Request for Additional Information No. 455(4911), Revision 0, Supplement 3

U.S. EPR Standard Design Certification

SRP Section: 19 - Probabilistic Risk Assessment and Severe Accident Evaluation

Question 19-341:**OPEN ITEM****Follow-up to Open Item RAI No 234, Question 19-304**

Figure 19-341-01—U.S. EPR CSDRS

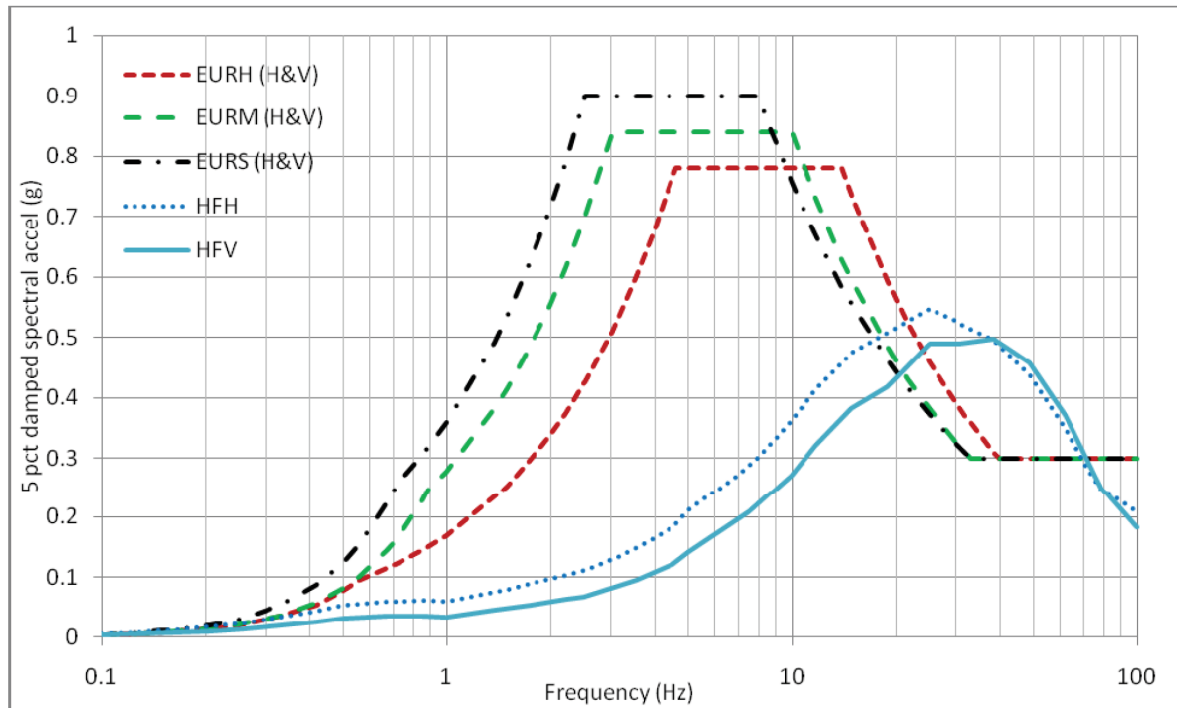
Revision 2, of the FSAR Section 19.1.5.1.1.5 provides a description of the seismic fragility analysis which, according to AREVA's response to RAI No. 234, Supplement 2, Question 19-304, was performed using the EPR Certified Seismic Design Response Spectra (CSDRS). The staff noticed that Figure 19.1-31 of Revision 2, of the FSAR Section 19 did not include the high-frequency hard rock spectra, which were added to the CSDRS. Revise Section 19.1.5.1.1.5 of the FSAR to provide a description of the seismic fragility evaluation consistent with the guidance of ISG-20, Section 5.1.2. Given that traditional fragility calculations are performed with respect to a single spectrum shape, the FSAR description should discuss the approach utilized to determine the fragility of an SSC for multiple spectral shapes as in the EPR CSDRS. In addition, for active SSCs identified in the cutsets, the FSAR description should discuss the use of generic data for fragility of active components qualified by tests consistent with the guidance given in the 3rd paragraph of Section 5.1.2 of ISG-20. Also, revise the FSAR to include the results of the fragility evaluation in terms of the median capacity and uncertainties.

The CSDRS of the U.S. EPR standard plant consists of three EUR control motions anchored to 0.3 g peak ground acceleration, and a fourth high-frequency (HF) control motion. The vertical EUR control motions are the same as the horizontal EUR motions. The high frequency horizontal (HFH) and the high frequency vertical (HFV) control motions are anchored to 0.21 g and 0.18 g peak ground accelerations, respectively. The horizontal and vertical CSDRS are provided in Figure 19-341-01. For design certification, the CSDRS is the safe shutdown earthquake (SSE) per RG 1.208. In response to the RAI, AREVA NP will revise U.S. EPR FSAR Tier 2, Figure 19.1-31 to show the CSDRS that include the high-frequency hard rock spectra.
